# SERVICE BULLETIN

M-971 November 11, 1988

# 1340 cc ENGINE THREE-PIECE FLYWHEEL ASSEMBLY, CODING (MARKING) OF CRANKCASE SETS & FLYWHEEL ASSEMBLIES, ALL MODELS

Figure 1. ID Codes, Outer Race Of 1340cc Engines

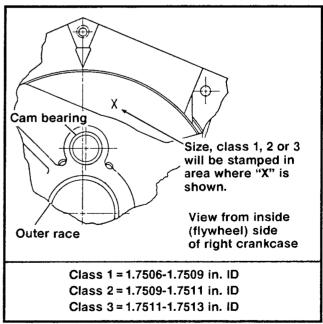
See Figure 1. The pinion shaft outer race (bore) inside diameter (ID) is marked on the inside surface of the right crankcase half as shown in Figure 1.

Figure 2. XLH Flywheel Identification

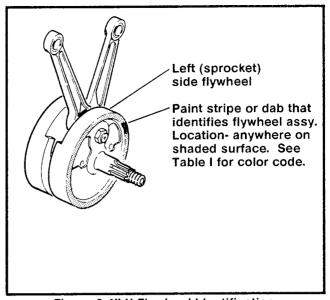
Beginning June 1st, 1988, flywheels forged from a micro-alloyed steel went into production. The part numbers and color codes of flywheel assemblies containing the new material were changed as shown in Table I. The changed flywheel assemblies are shown in bold type. Figure 2 shows the location of the color code that identifies what displacement engine the flywheel assembly was balanced for.
